March 1, 2016

**Re: Conn Commercial Development, Township of Southgate
Response to MTO Comments**

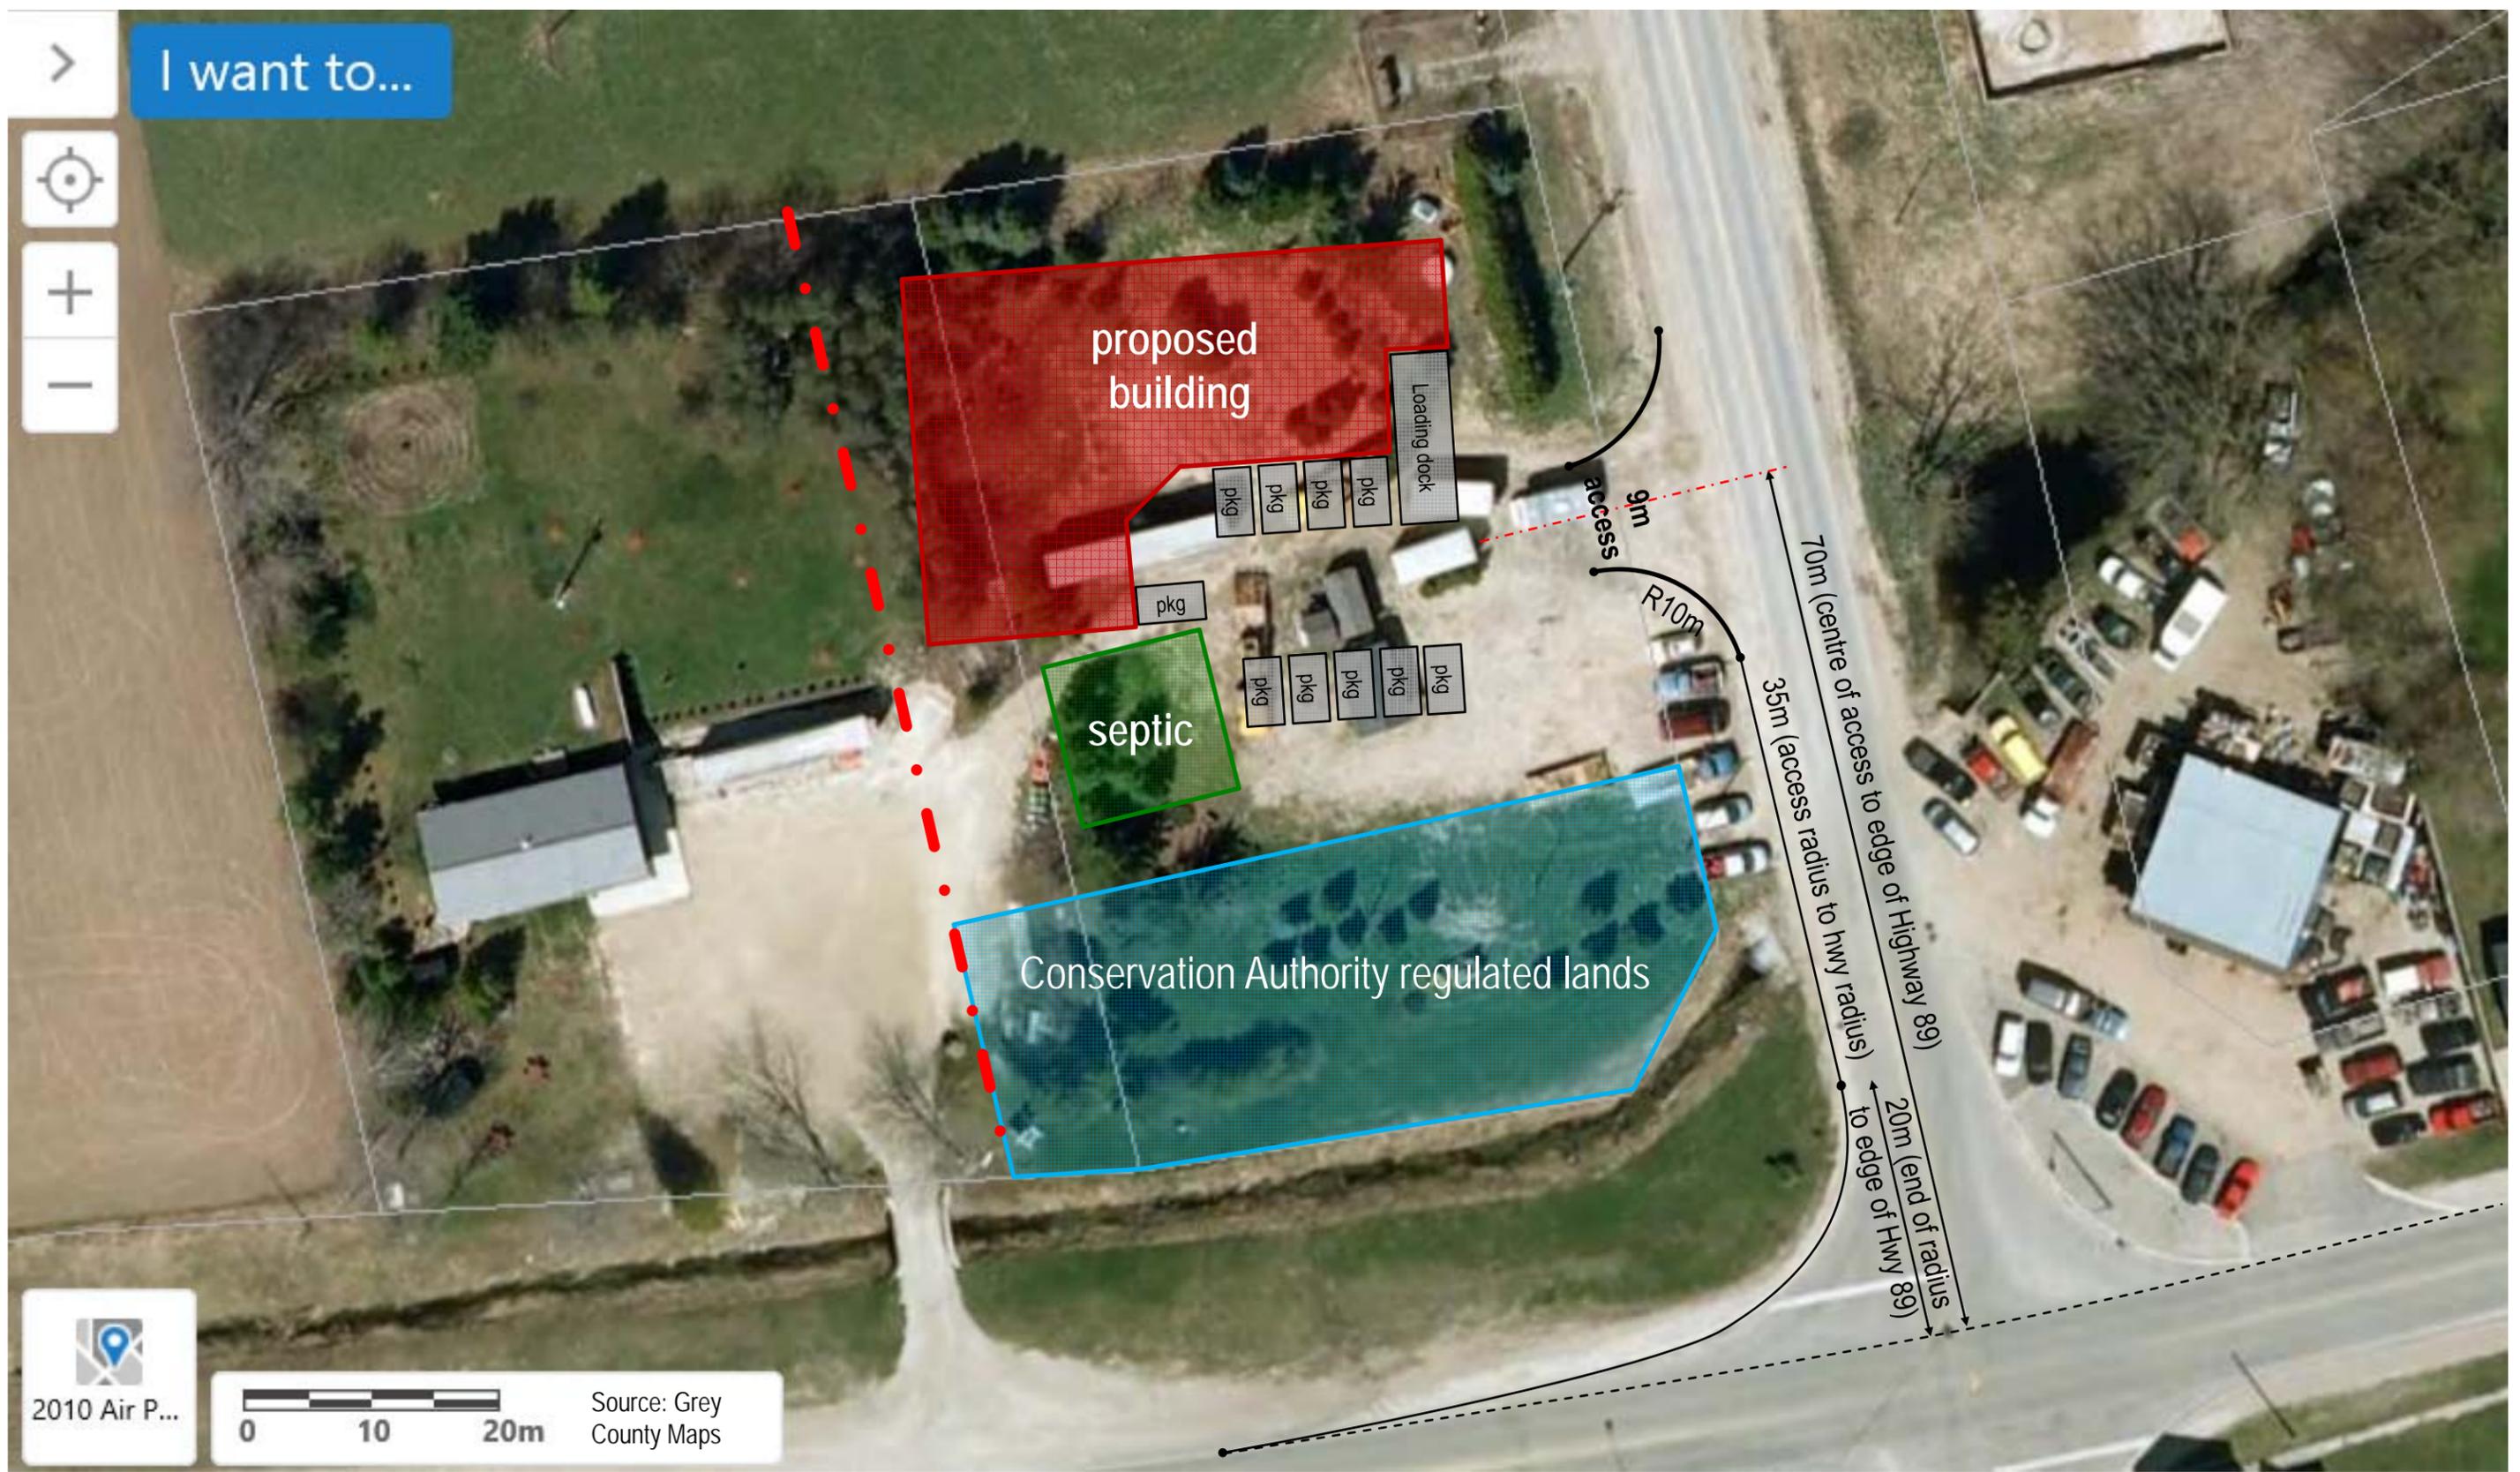
The initial site access location is illustrated in Figure 1, in context of the existing conditions and proposed development. With respect to the siting of the building on the site, the following are noted:

- the local conservation authority has established a regulated area, within which development is not permitted;

- there is an existing water well in the NW corner of the site;
- the placement of the septic system is dictated by the conservation regulated area and the requirement to provide a suitable offset from the water well;
- the placement of the building is in turn based on maintaining the required setbacks from property line and the septic system, and also in consideration of the well location and the regulated area,
- the building needs a loading dock for tractor-trailers, with a desire to have it on the east side to minimize on-site circulation and conflict between trucks and cars; and
- the site access needs to be located to ensure appropriate manoeuvrability on site without interfering with the loading dock.
